Administrative Approval Action

Case File / Name: ASR-0075-2021
DSLCL - Sumner Pointe II Phase 4/ Lot 2

REQUEST: An affordable four story 120,034 square foot congregate care facility with amenity areas and associated infrastructure.

SITE PLAN

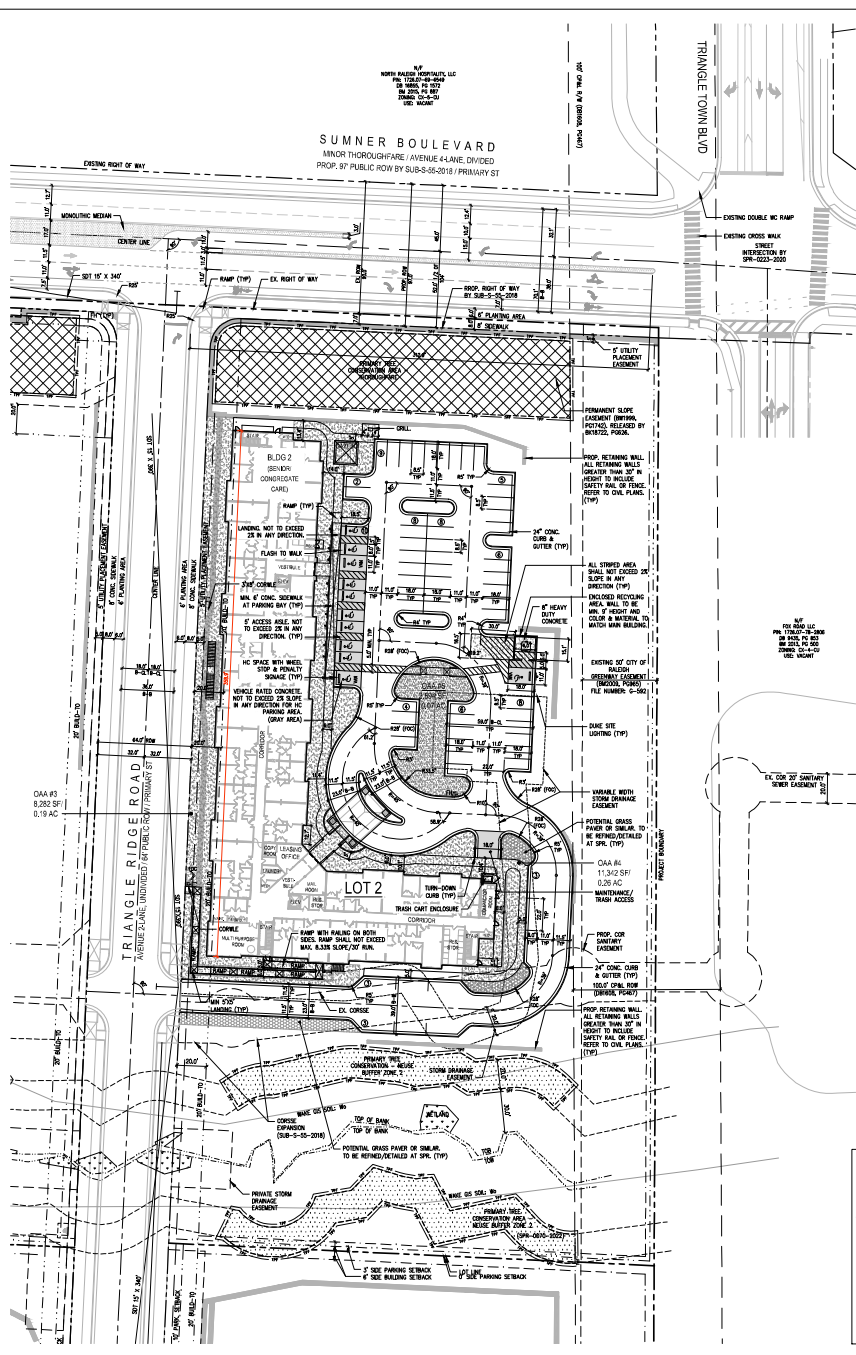
1. Approval and recordation of SUB-S-55-18 is required prior to SPR approval for this ASR plan.
2. Revise site plan sheet (LS1.1) labeling - See sheet LS1.1.
 - a.) in regards to primary and side streets (meeting pre text change conditions in accordance with BOA approvals).
 - b.) Under site data table - revise/clarify describing how side street build to (Sumner Blvd) is being met
 - c.) Under site data table, note #3 at the bottom - Clarify description as to how side street (Sumner Blvd) build To is being met.
